Response to RC1:

The authors of this paper implement an extended Budyko framework for high-elevation catchments to understand the changes in water balance characteristics. Additionally, they tried to isolate the major drivers of monthly runoff variability in the region.

Response to RC2:

Figure 1. (a) Geographic locations, (b) elevation of the 10 sub-basins (based on data from the U.S. Geological Survey), and (c) mean annual snow depth (based on data from the National Tibetan Plateau Data Center) for the period 2002-2016 in the Yalong River basin.

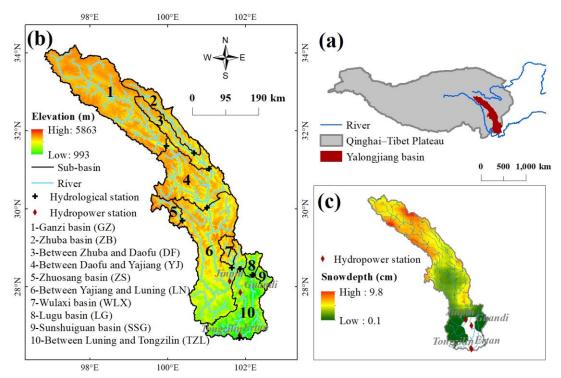
Comments 13: The labels of the sub-basins are not clear in Figure 2. Consider making them bold/bigger. Also, provide information on the source for the DEM and snow depth data in the figure. Labelling the three figures as (a), (b), and (c) and providing a proper caption for each will bring more clarity.

Response 13: We thank the reviewer for these helpful suggestions. We have revised Figure 2 by improving label clarity, adding data source information, and labeling panels (a), (b), and (c) with updated captions, as shown in the revised figure (Figure 1).
